March 10, 2008
261-4779-LTR-04

Subject: Resolution of NRC Questions Regarding ALION VUEZ 30 Day Testing Program
Status of Responses

Alion Problem Statement No. 1

Alion Problem Statement No. 4

Figure 1d – Formed Debris Bed

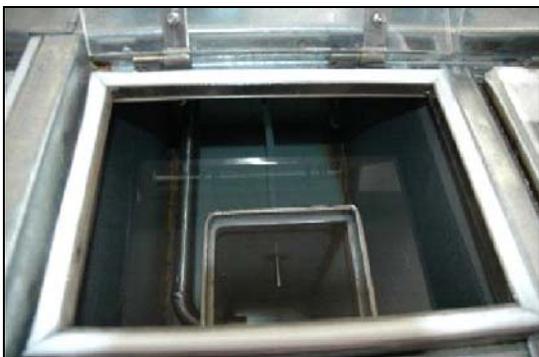
- 1. Alion should demonstrate that head loss results from VUEZ testing with poured debris beds prior to the addition of chemicals are representative of non-chemical integrated tank testing***

- 3. Alion should demonstrate (a) why the addition sequence for the VUEZ test debris is representative of the actual plant condition and (b) the basis for using a bump-up approach in light of the fact that a different debris addition sequence was used in the Warrenville array tests and the VUEZ tests.**

- 4. Alion should (a) ensure that debris added to future tests is in a form that is representative of the plant debris described in the debris transport calculation and (b) demonstrate that testing conducted to date with a generic size distribution that led to significant debris clumping is adequately representative of the plant conditions predicted in the debris transport calculation.**

The VUEZ 30 day debris head loss testing represents a combination of ICET and vertical loop debris head loss testing. The screen installed in the experiment is a horizontally oriented flat plate on which the plant specific debris bed was developed and head loss measured (see Figures 1a through d). The screen is slightly spherical on the bottom to inhibit the formation of voids that may build up underneath the debris bed. The sump solution is circulated in the areas outside the suction plenum and drawn down through the debris bed and recirculated.

The fiber and particulate mixture is thoroughly mixed in a beaker containing the test solution (Figure 4 a & 4b). The mixture is slowly added through a funnel to ensure an even distribution across the test screen area while the pump is circulating (Figure 5). The bed is constructed to be uniform (minimal clumps, unevenness, etc.) to the extent possible by the technicians. A close up of actual completed bed (witnessed during the NRC visit) is provided in Figure 6.

Figure 8: Sample VUEZ Vertical Screen Debris Beds

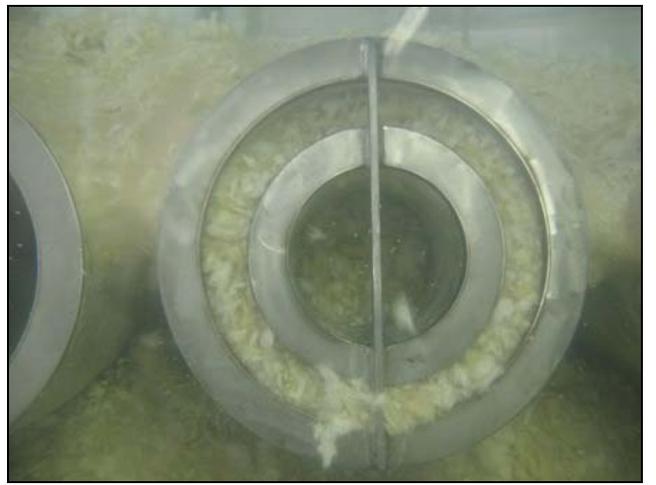
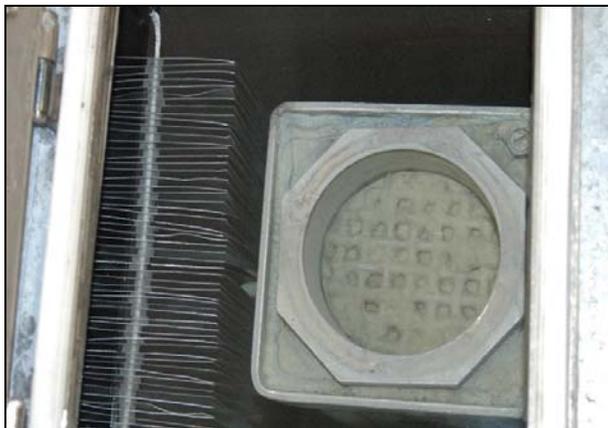
The concern by the staff appears to be clumpy-ness of the debris bed and technique of forming the debris bed by moving the funnel containing the material around the screen area witnessed during one of the experiments. It was pointed out by the staff that this does not appear to represent the debris bed formed in the non-chemical tank test – thereby questioning the application of any results. The issue boils down to the representativeness of the debris bed porosity at VUEZ compared to that of the non-chemical tank tests. Although the concern is primarily driven by the observed debris bed formation, the staff also alludes to the relatively low head loss results at VUEZ. We'll begin to address this issue first with the comparison of the beds formed during the non-chemical tank testing (e.g., Warrenville Hydraulics Lab, CDI, etc.).

First, the materials are procured by Alion and received at the Warrenville Laboratory; they are subsequently packaged and sent over to VUEZ. The materials (fiber, particulate, Cal-Sil, etc.) therefore are identical between the two facilities and experiments. Alion's process for "destroying" bulk fibrous insulation is to run the fiber blanket through a leaf shredder, which is common industry practice. The fiber is then weighed and boiled to remove oils and trapped gases that may cause the fibers to float when introduced into the tank. The soaked fiber is then poured into a larger mixing container (5 gallon bucket) with more water and particulate. The particulate and fiber slurry is then "mixed" or "beat" using a motorized paint mixer (attached to a drill). The non-chemical test consists of a full tank of water circulating through the prototype screen at the prescribed flow rate and temperature. The 5 gallon bucket(s) are then dumped into the large tank with the prototype screen in the discharge (return) flow to minimize settling. Most of the material accumulates on the sump screen. Some of the material tends to sink and collect in corners of the tank. This material is "agitated" by trolling motor, paddles, stirs, etc., to coax it onto the screen. This process is designed to ensure that the debris accumulates on all surfaces of the screen with minimal gravitational settling. As the debris collects on the screen and develops head loss, additional debris is attracted to those clean screen areas based on velocity. The debris loads or distributes in such a manner as to maintain the lowest possible head loss through the entire surface area. The resulting debris beds are shown in Figure 7.

The debris materials for VUEZ are bulk processed the same way in that they are shredded, boiled and then baked as shipped materials need to be dry. VUEZ processes the debris materials further and finer as described earlier in this letter. A sampling of 6 different debris beds is provided in Figure 8. As evident from the two (2) sets of pictures, the VUEZ beds are reasonably representative, and "finer" than those used in the non-chemical tank testing.

Figure 7 – Example of Bed Shrinkage

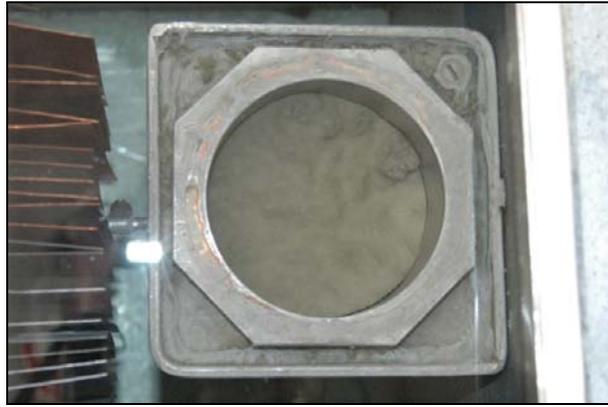
9. Alion should (a) demonstrate that flow diversion through the thinner debris bed cross section caused by circumferential warping has not had a significant adverse impact on testing conducted at VUEZ and (b) describe measures taken to prevent or minimize this observed phenomenon in future testing.

Alion has seen a few debris beds that may shrink under the high temperature and environmental aging associated with the chemistry and pull away from the sides of the debris cup (Figure 7). Although the debris beds still exhibit appreciable head loss, there is a concern regarding by-pass flow around the edges of the debris bed. This condition was identified by Alion and the NRC during their visit. To preclude any apparent issues associated with by-pass flow due to environmental effects (shrinkage), ALION/VUEZ modified the test screen by welding a seal ring in near the bottom. This essentially creates an o-ring to prevent by-pass flow. The bed is compressed down onto and under the seal ring to provide a more effective seal in the event of bed shrinkage at the perimeter.

The results to date have not changed appreciably with and without the metal o-ring. Alion has not identified any bypass flow in the earlier testing. The change to install the o-ring was an improvement to remove any concern that might arise. The installation of this o-ring does not in any way imply that by-pass flow was observed in the past or question the results of the earlier work.
